A change to the front drive shaft during production required additional maintenance information in the form of an addendum to the 2020 UFORCE 1000 Owner's Manual for vehicles with production build dates between *September 5<sup>th</sup>, 2019 and November 19<sup>th</sup>, 2019*.

## **Front Drive Shaft Universal Joint Lubrication (Applies to vehicle build dates September 5<sup>th</sup> to November 19<sup>th</sup> 2019)**

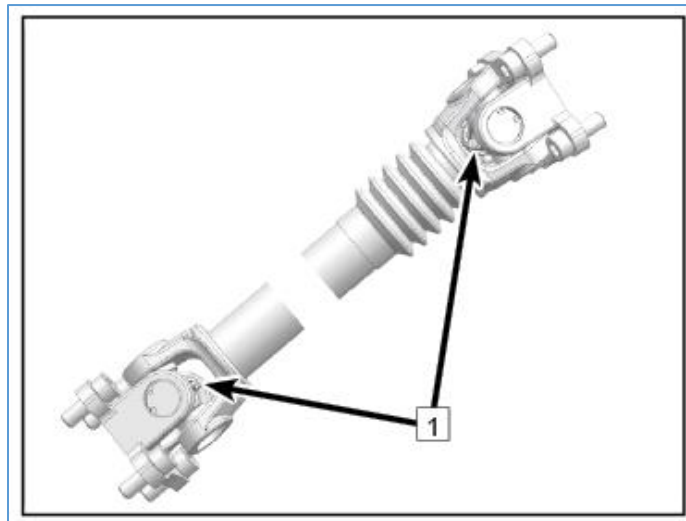
Please reference the following for front drive shaft maintenance information if your UFORCE1000 UTV has a build date between *September 5<sup>th</sup>, 2019 and November 19<sup>th</sup>, 2019*:

Inspect and lubricate according to the maintenance schedule in the owner's manual. If the vehicle is operated in severe conditions, apply grease at the grease nipples more frequently.

To lubricate the universal joints of the front drive shaft:

- Front – Remove the front skid plate to gain access to the drive shaft universal joint nipple at the gear case.
- Rear – Remove the passenger seat bottom and tool box to gain access to the drive shaft universal joint nipple at the engine.
- Apply grease to the front and rear grease nipples (1) until grease begins to flow from the joint.
